Subject: Project name _____
 Project site address 1719 Brickell Way
 Permit # B25005267 SDP # _____
 Other information pertinent to this project _____

PERMIT SITE PLAN
LOT 3
SANTORINI
ELEVATION: F
SCALE: 1"=40'
DATE: 6/12/2025
DRAWN BY: ZLL
CHECKED BY: FM II
PROJECT No.: J7040

Permit Type: Building/Residential/Misc/Tanks
 Permit Number: B25005267
 Opened Date: 11/24/2025
 Description of Work: SFD// INSTALL (1) 1000GAL UNDERGROUND PROPANE TANK

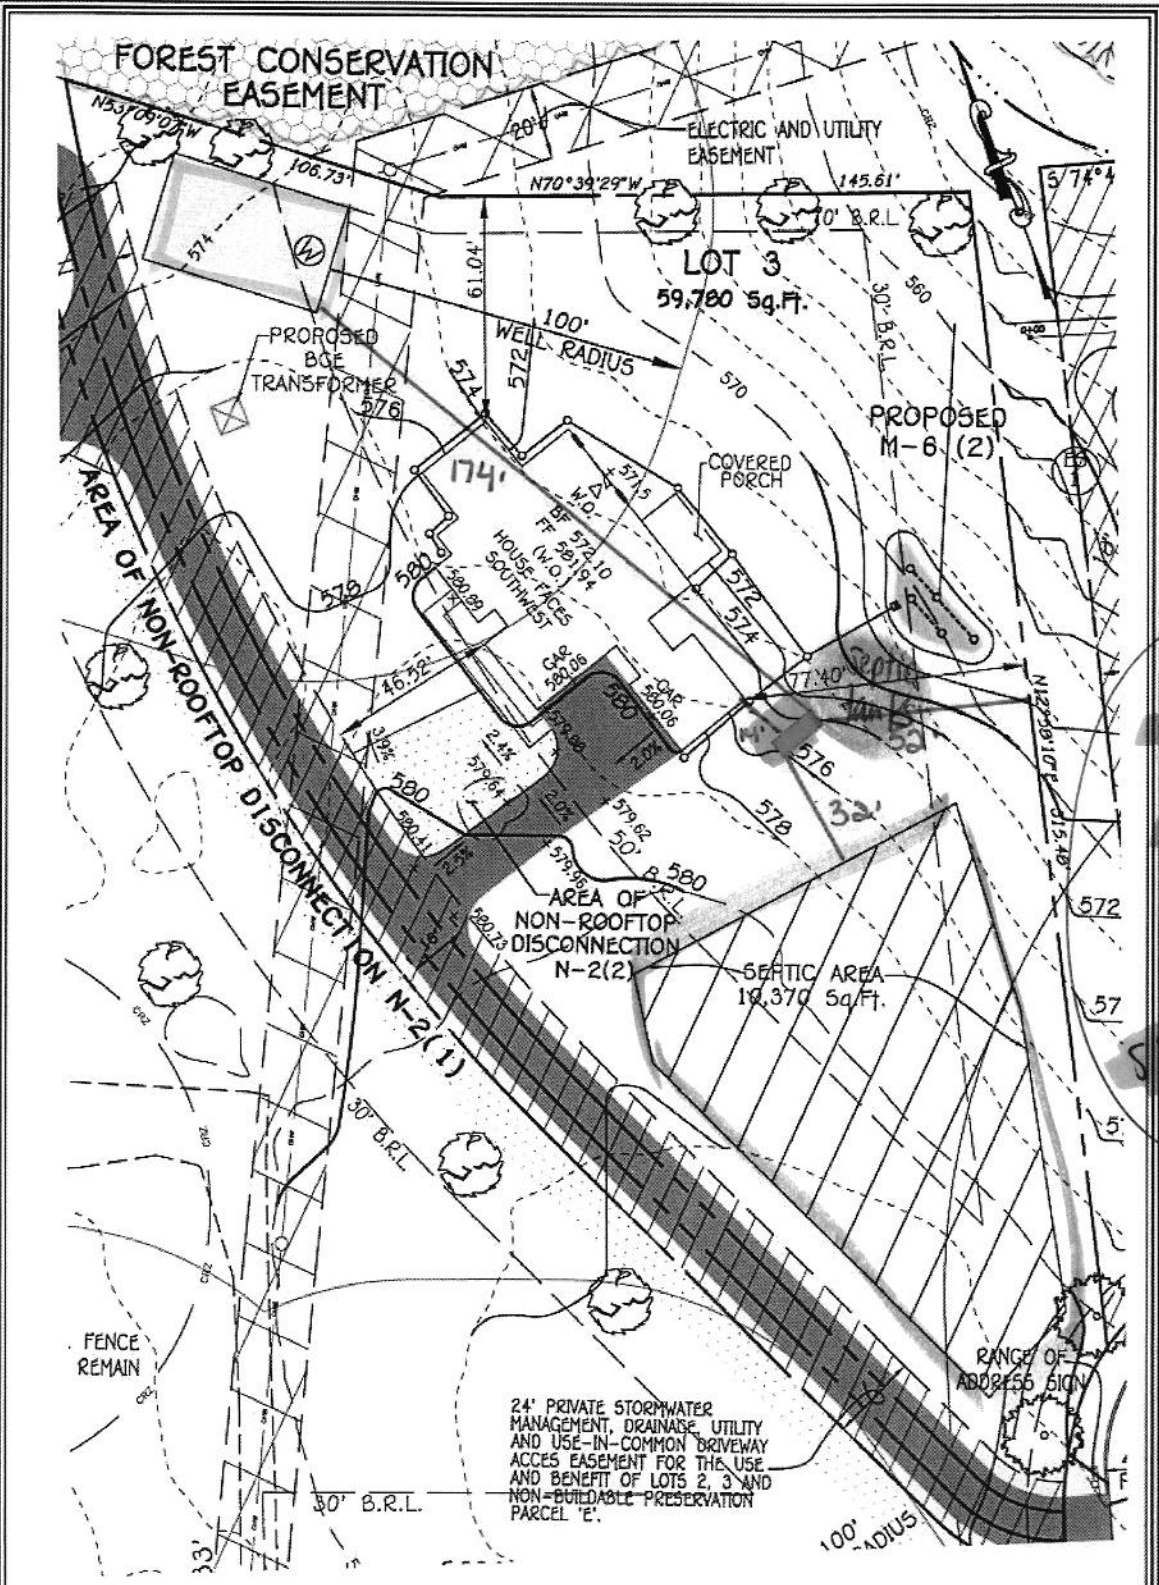
see pic
septic
rooms
in
black
area

12/1/25 - si - proposed location for lp tank is in close proximity to the OSDS for the property which is already installed. (P)

12/2/25 - email sent to AH requesting that the plan be revised to show the OSDS and the setback to the proposed location for the lp tank. (P)

See revised
plan
dated
12/12/25
shows septic
tanks

12/12/25 - revised plan rec'd. (P)

12/16/25 - approved (P)

Revised plan
w/ septic

Approved for 1p tank
B25005267
12/16/25
